TO: Mountain Village Design Review Board

RE: Staff Memo – Initial Architecture and Site Review (IASR) Lot SS811, 2 Mountain Village Boulevard pursuant to CDC Section 17.4.11

APPLICATION OVERVIEW: New Single-Family Home on Lot SS811

SHEET NUMBER:
A601

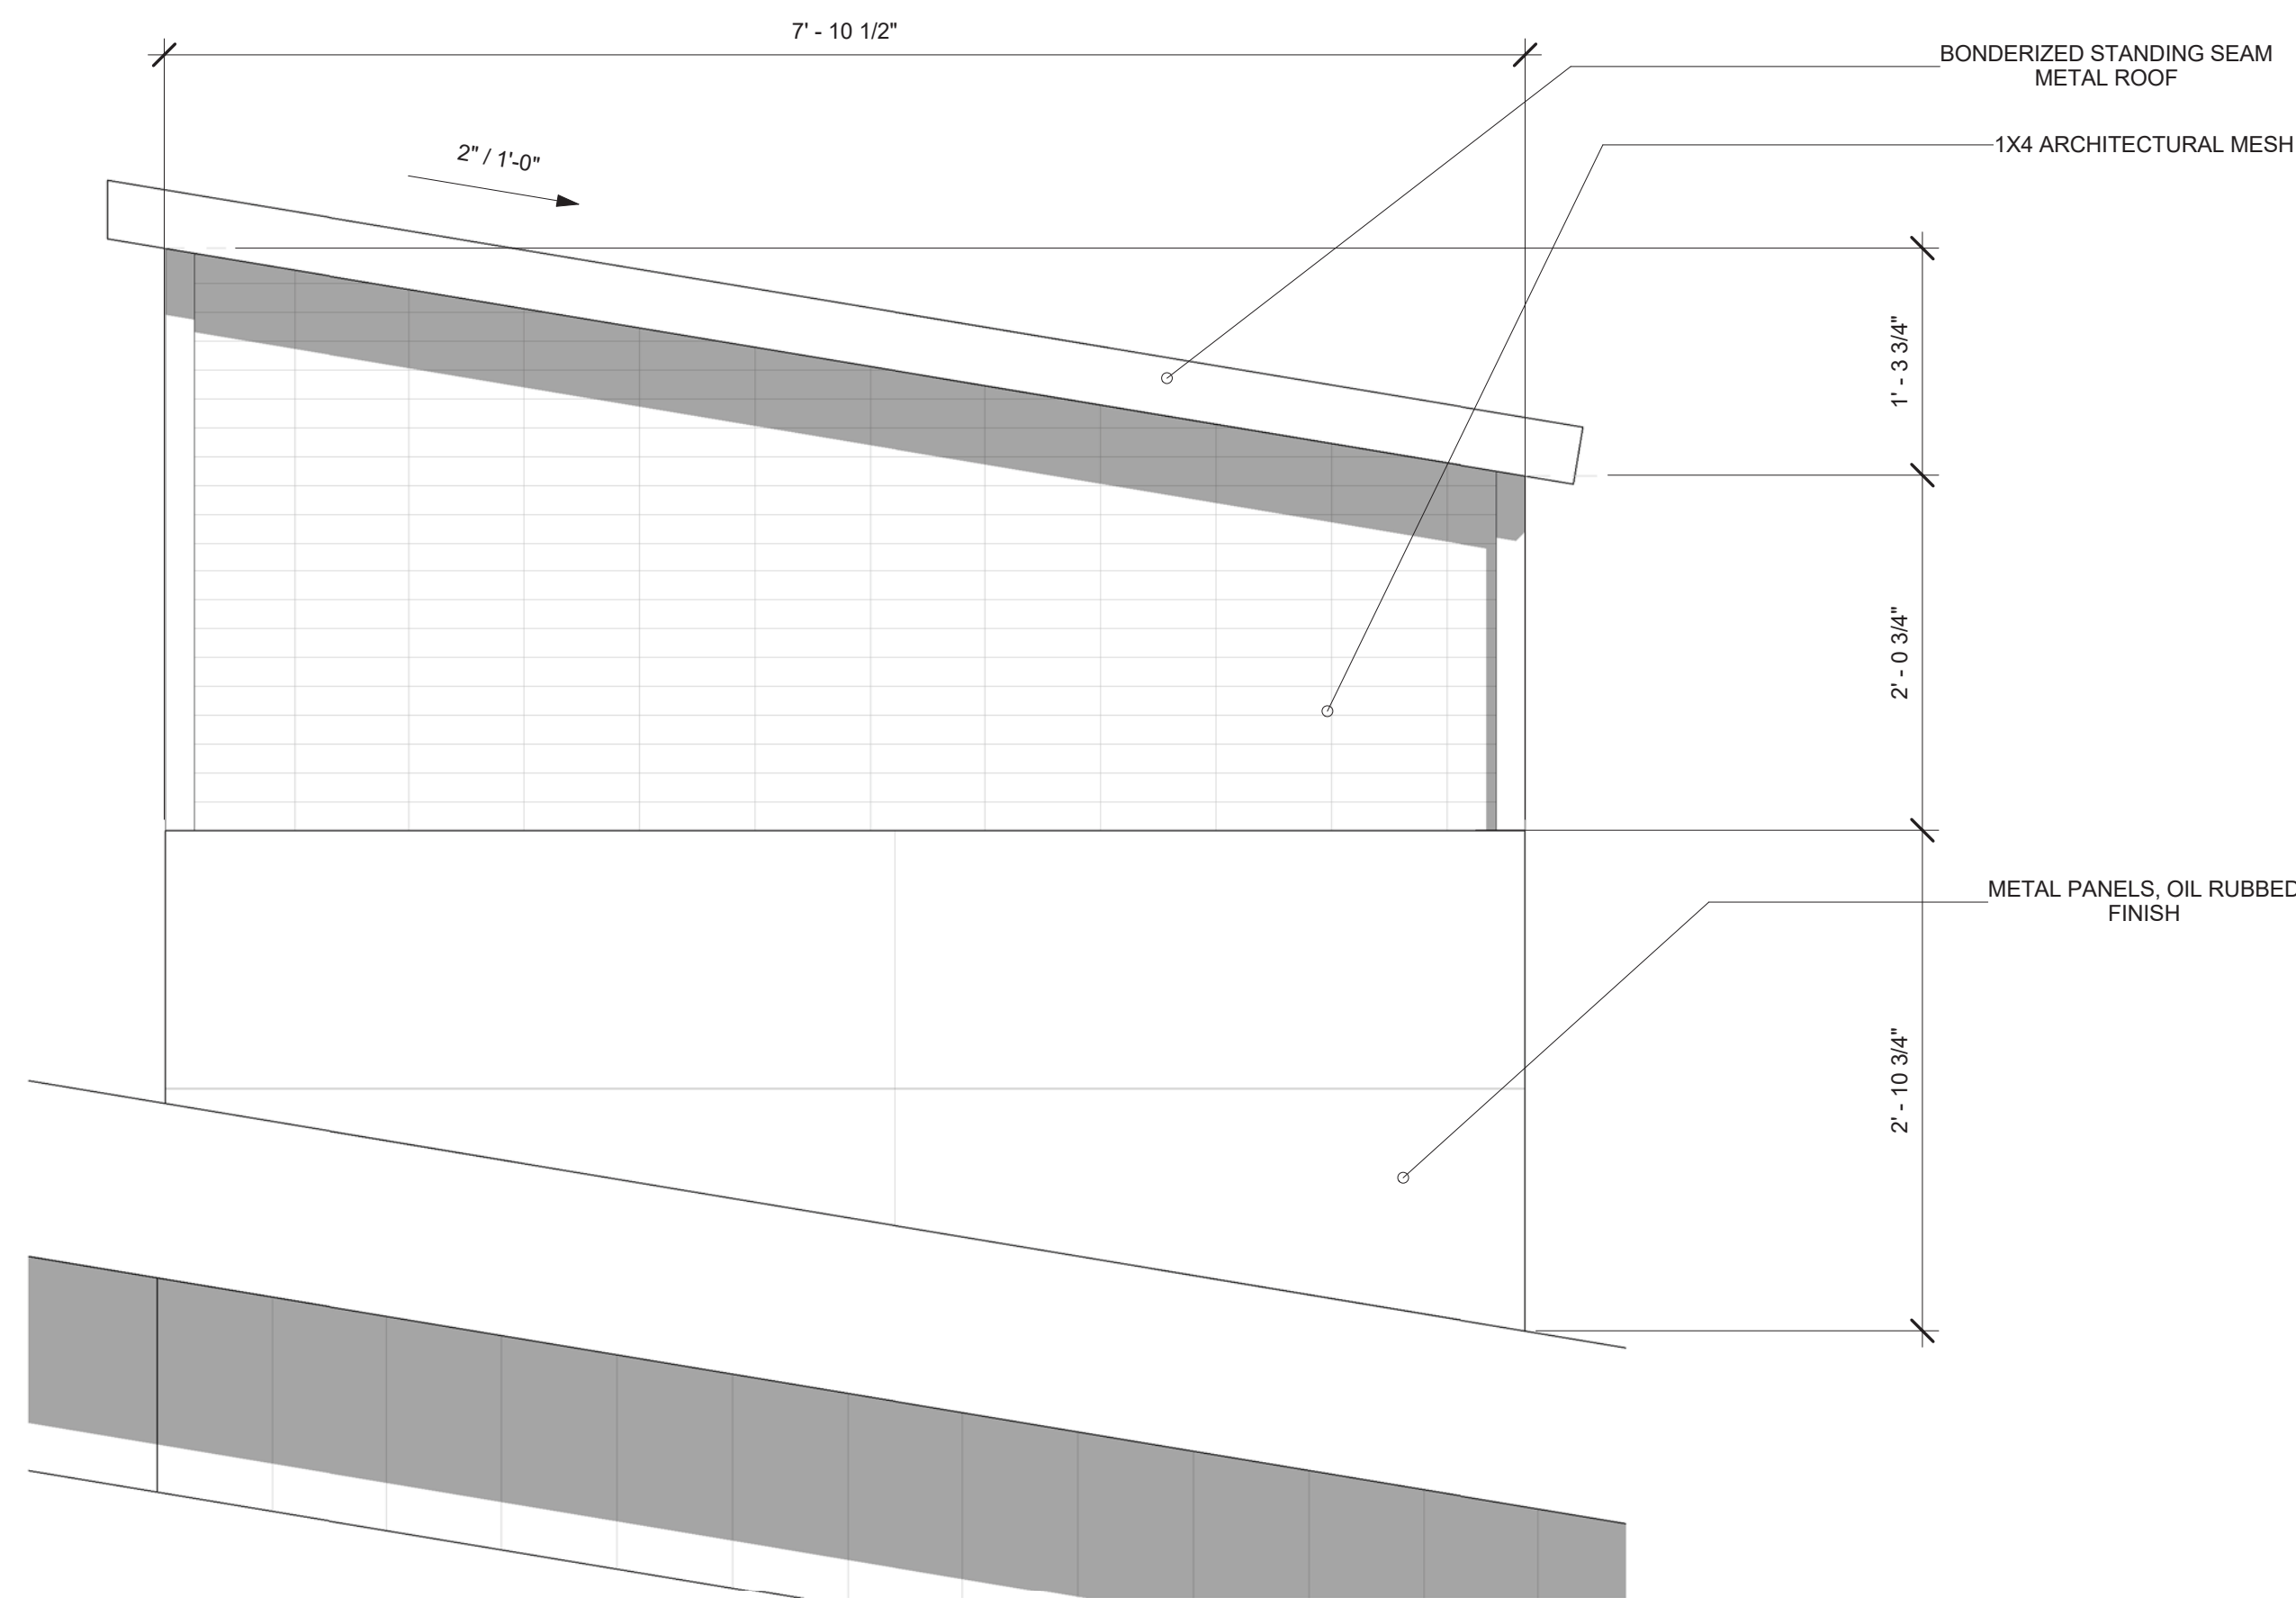
The maximum window area of the building, including window and door glazing, is 24.2 percent of the total building façade for the main house and 24.1 percent for the cabin. Exhibit A Sheet A601 shows the window schedule. Windows for both structures utilize a mix of wood and stone siding. The windows and doors are trimmed with metal clad but the color of the cladding is not specified. This should be identified prior to final and is a required condition of approval.

① GARAGE DOOR DETAIL
3" = 1'-0"

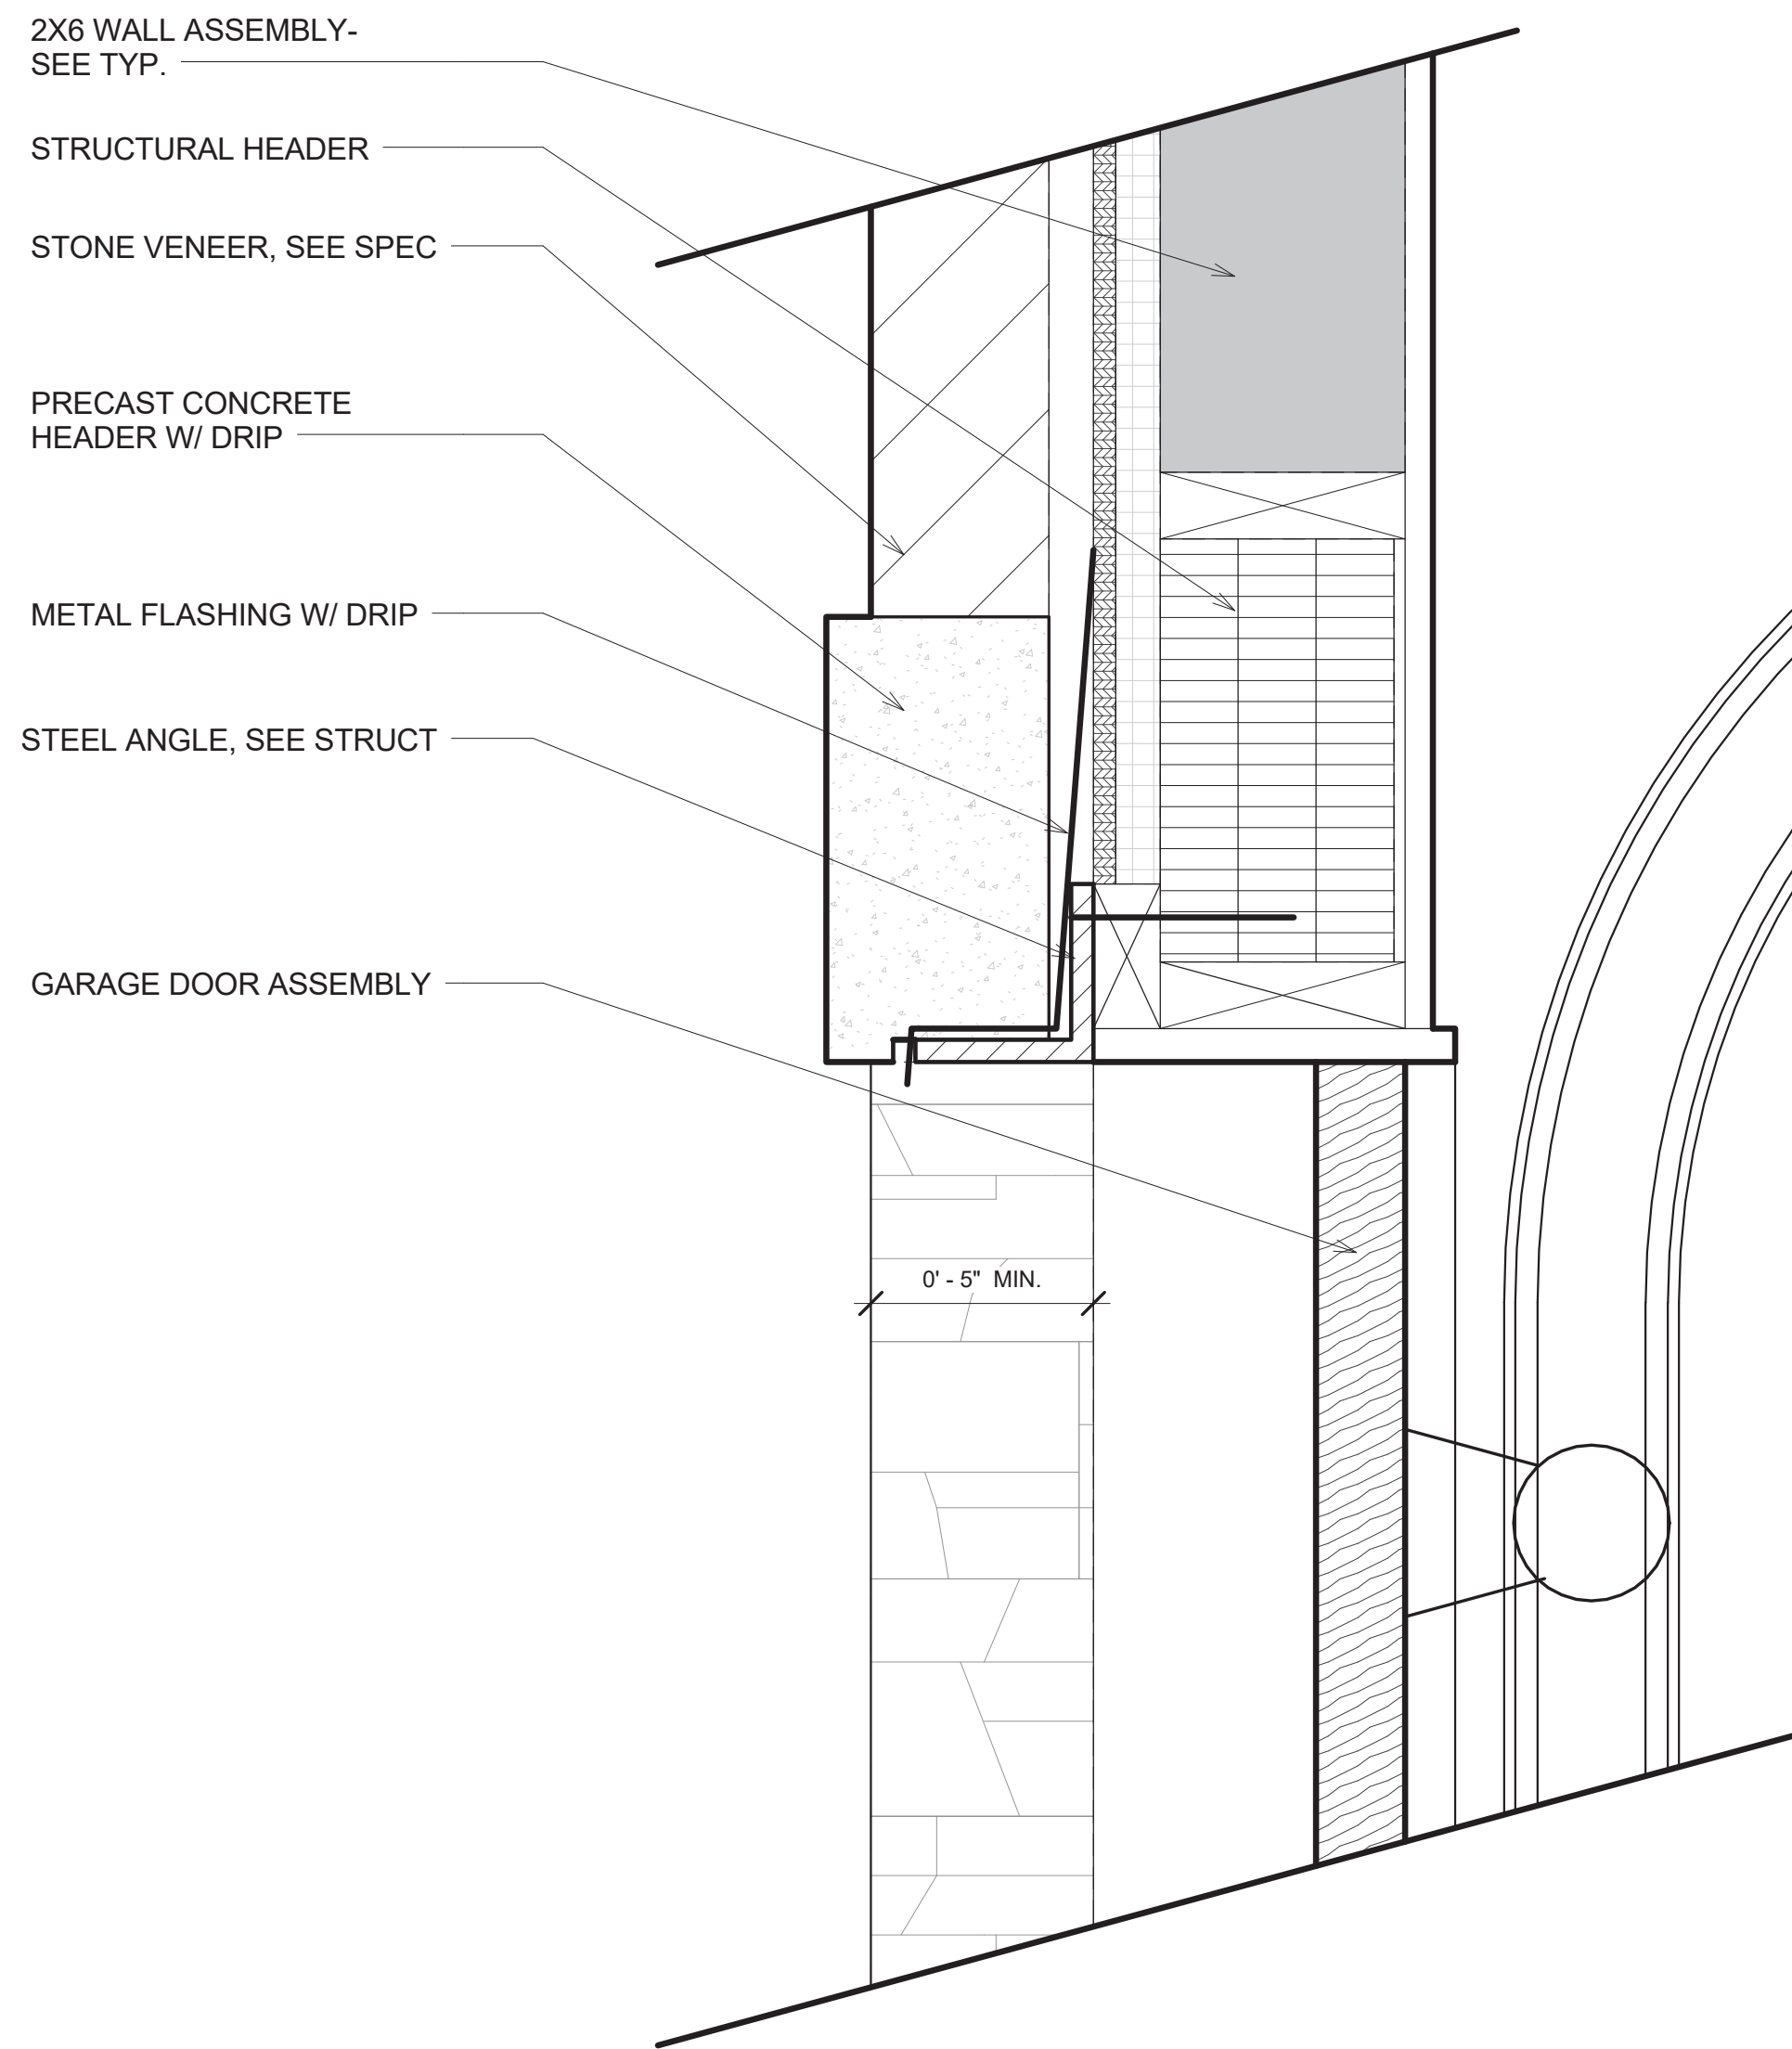
The garage door detail for the main house is shown on Sheet A602. The applicant has not provided a door schedule for either structure.

SHEET NUMBER
A810

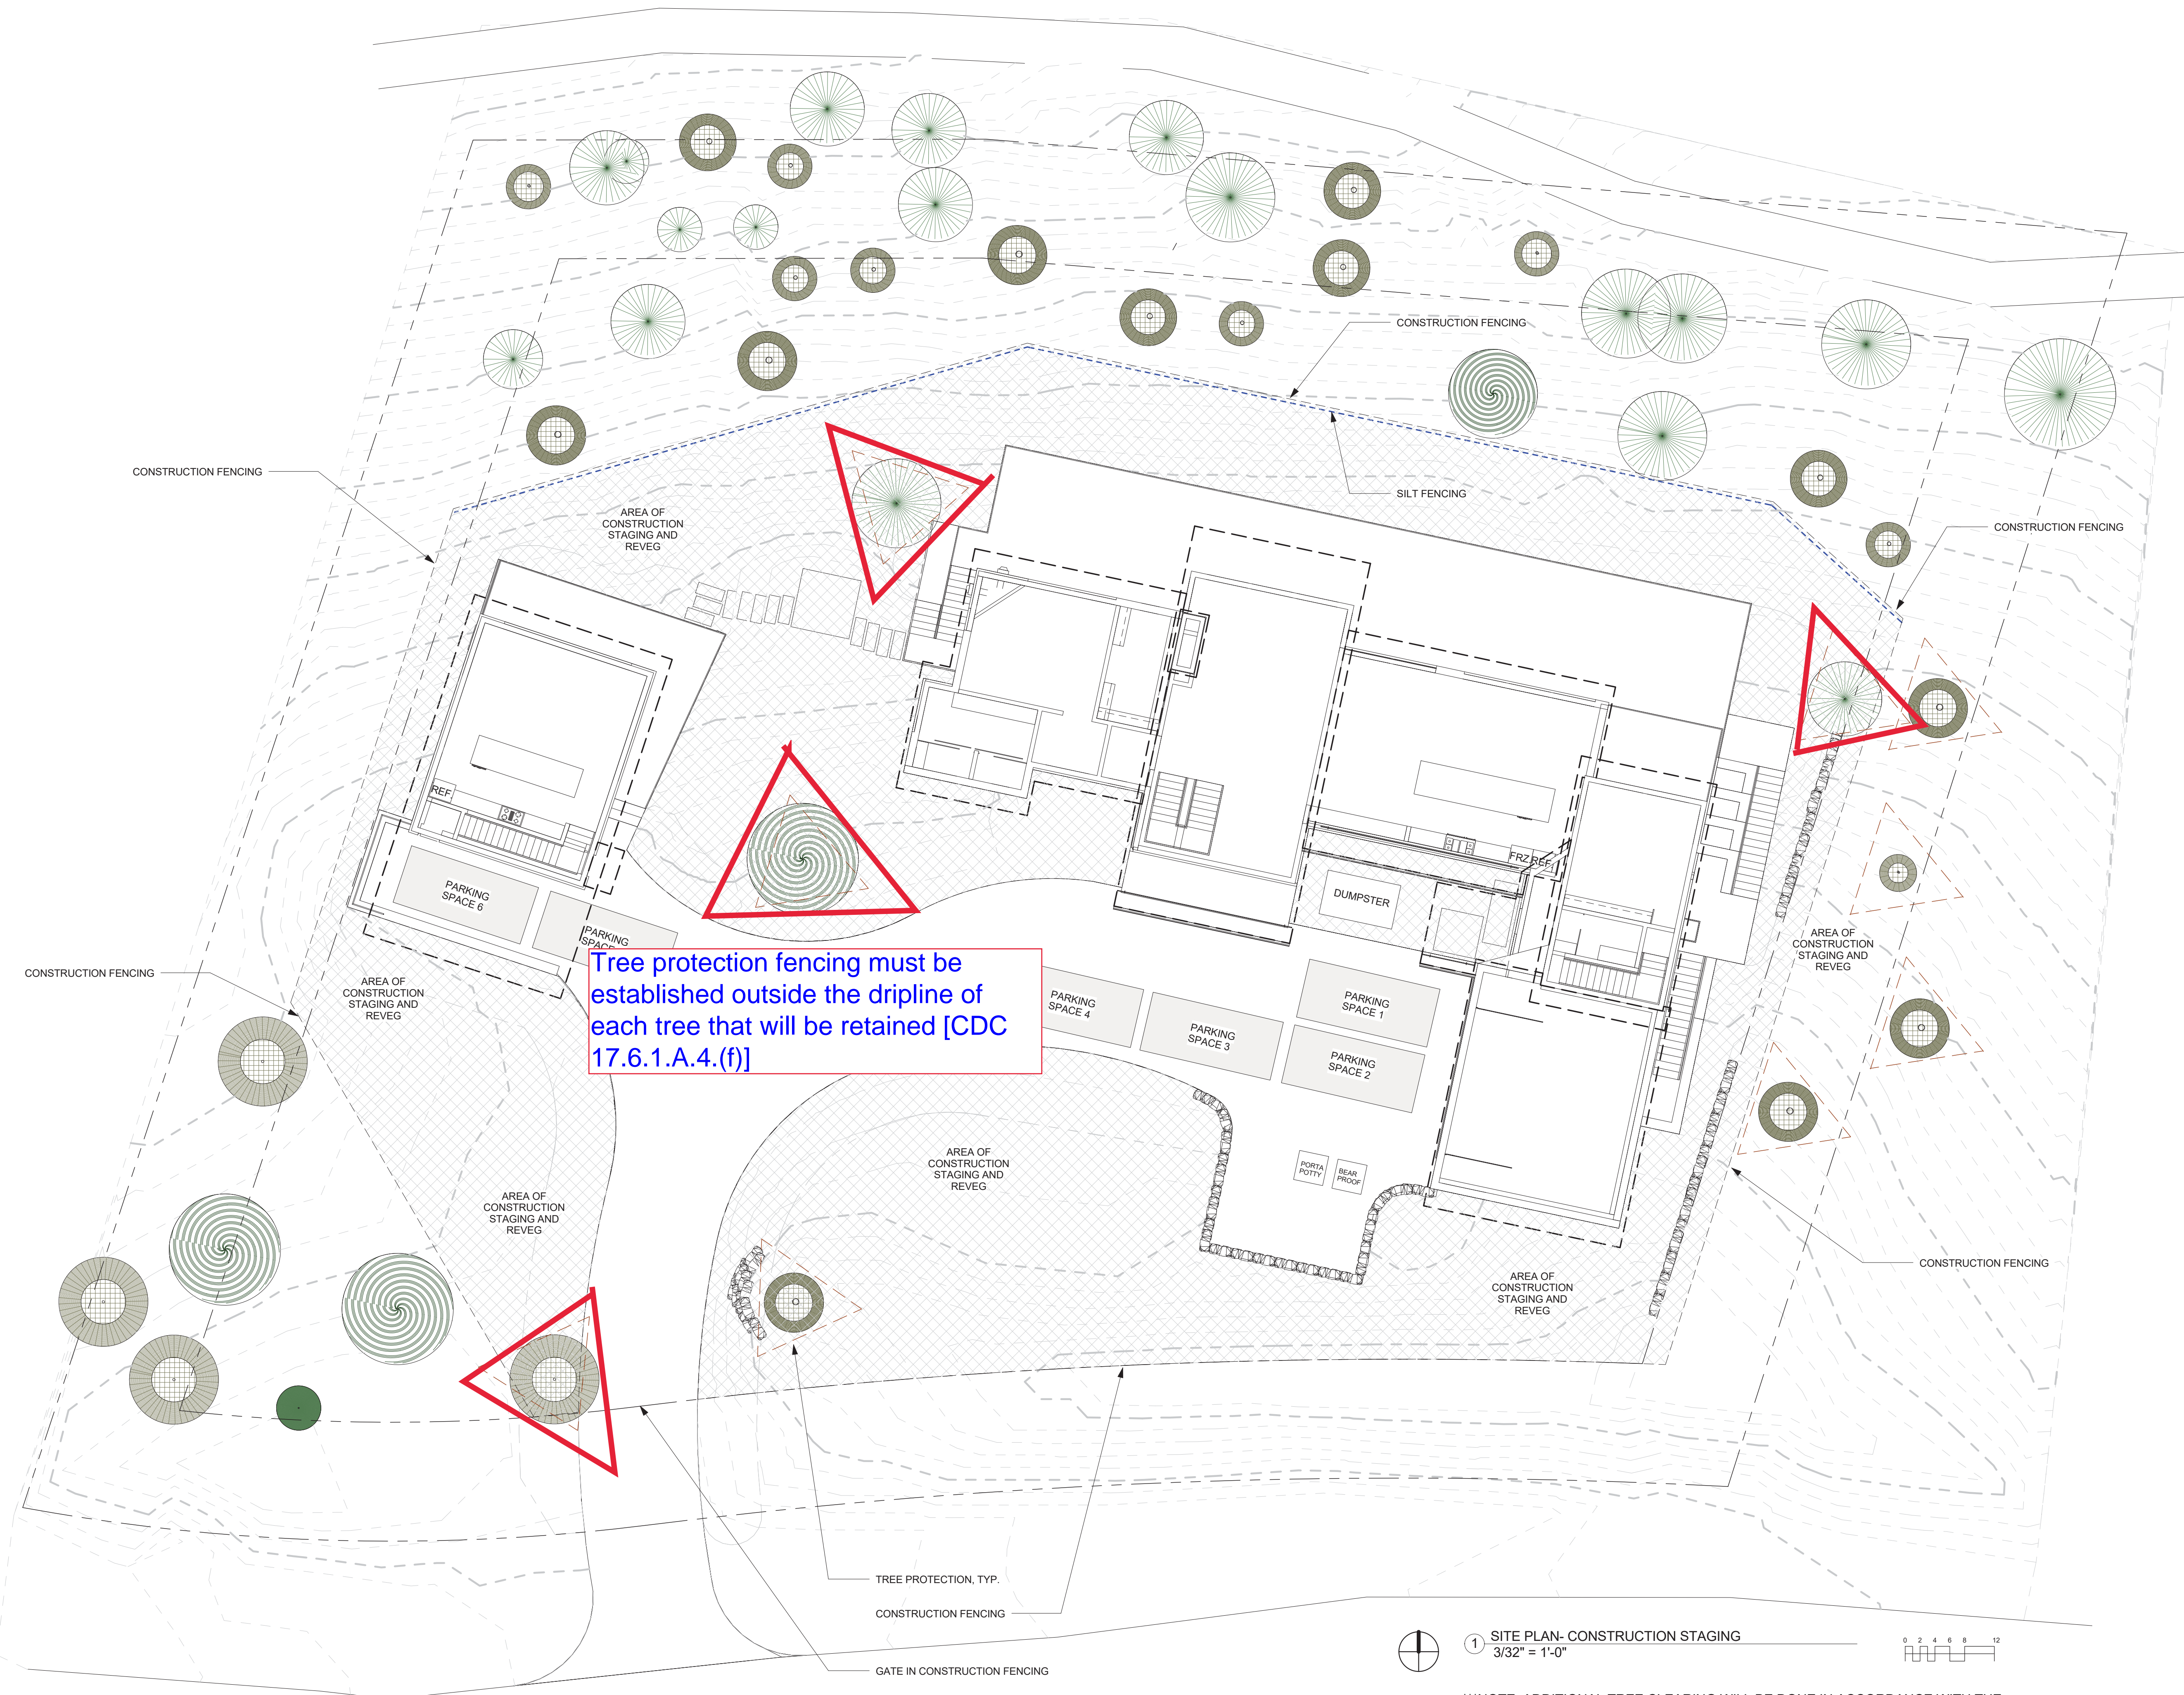
Staff: Lighting information was provided on sheet A810 of Exhibit A, including rope lights, step lights, and outdoor sconces. The step lights and sconces are LED and all three light sources do not exceed the 850 lumen limit and will be on a dimmer management system.
